Item Name: Crosstube Aft

DART AEROSPACE LTD		Work Order:	89183
Description: Crosstube High Aft (412)		Part Number:	D412-664-203
Inspection Dwg: D412-664-243 Rev: E		Page 1 of 1

DRAWING NO. D412-664-243	TITLE CROSSTUBE ASSEMBLY (412 HI AFT)	REV. E	DART AEROSPACE LTD ENGINEERING ORDER		D.E.O. NO. D412-664-243-E-1	SHEET NO. SHEET 1 OF 2	SCALE NTS
DRAWN	CHECKED <i>MP</i>	MFG. APPR. <i>E</i>	APPROVED <i>MP</i>		DE APPR. <i>MP</i>		
DATE 11.03.31	DATE 11/03.31	DATE 11.03.31	DATE 11/03.31		DATE 11.03.31

**D412-664-243
ASSEMBLY DETAIL**

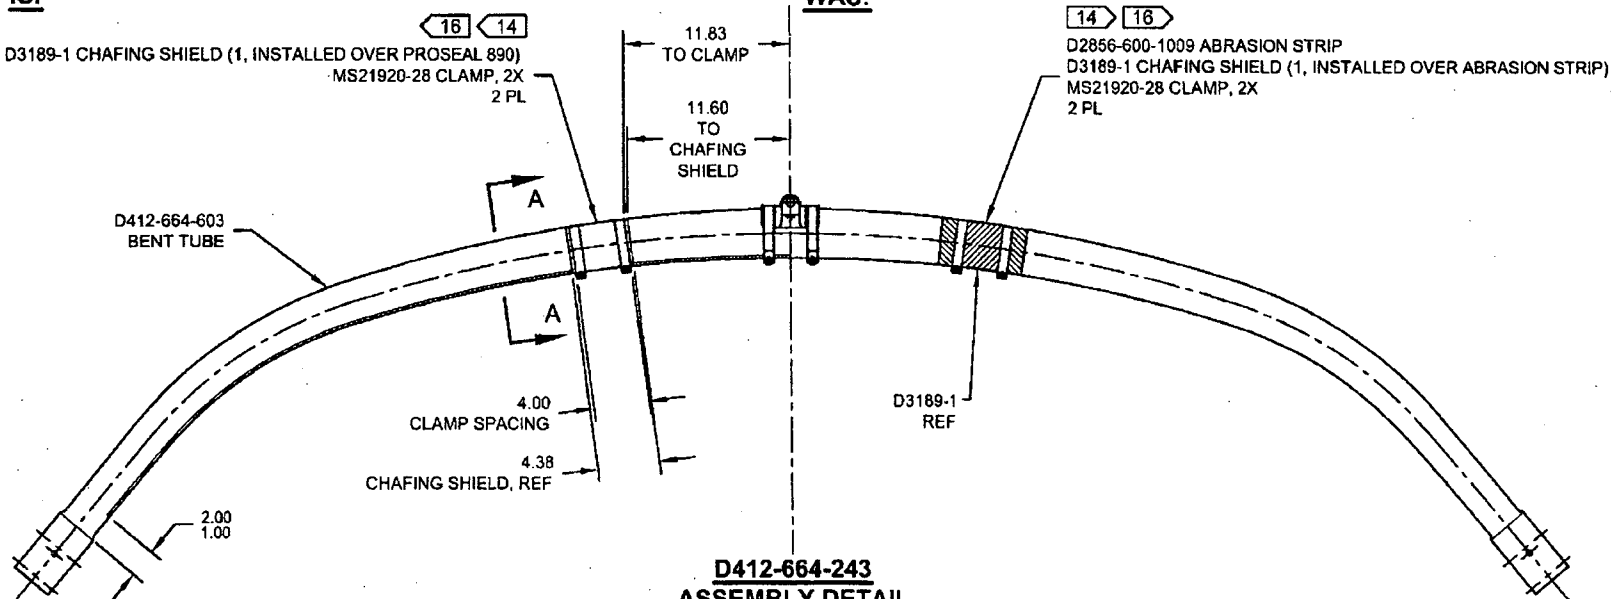
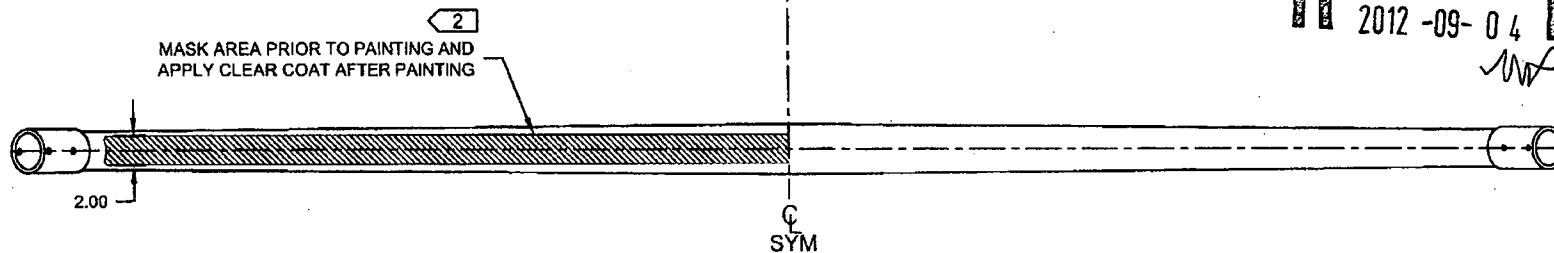
REMOVED ABRASION STRIP IN FAVOR OF A THIN LAYER OF PROSEAL 890. UPDATE INSTALLATION OF CHAFING SHIELDS AND REDUCE TORQUE TO 40-50 IN-LBS. THIS ENGINEERING ORDER SUPERCEDES DEO D412-664-243-E-1.

IS:

D3189-1 CHAFING SHIELD (1, INSTALLED OVER PROSEAL 890)
MS21920-28 CLAMP, 2X
2 PL

WAS:

D2856-600-1009 ABRASION STRIP
D3189-1 CHAFING SHIELD (1, INSTALLED OVER ABRASION STRIP)
MS21920-28 CLAMP, 2X
2 PL

CRUSHING OF D412-664-243

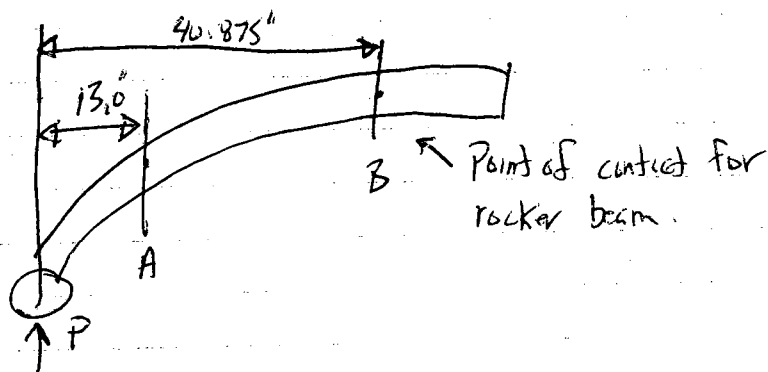
Acceptability of 8% CRUSHING AT END OF BEND

Point A: $OD_1 = 2.961"$, $OD_2 = 2.522"$
 $CRUSHING = (2.961 - 2.522) / (2.961 + 2.522) = 8\%$
 $I = 1.676 \text{ in}^4$ (from AutoCAD)
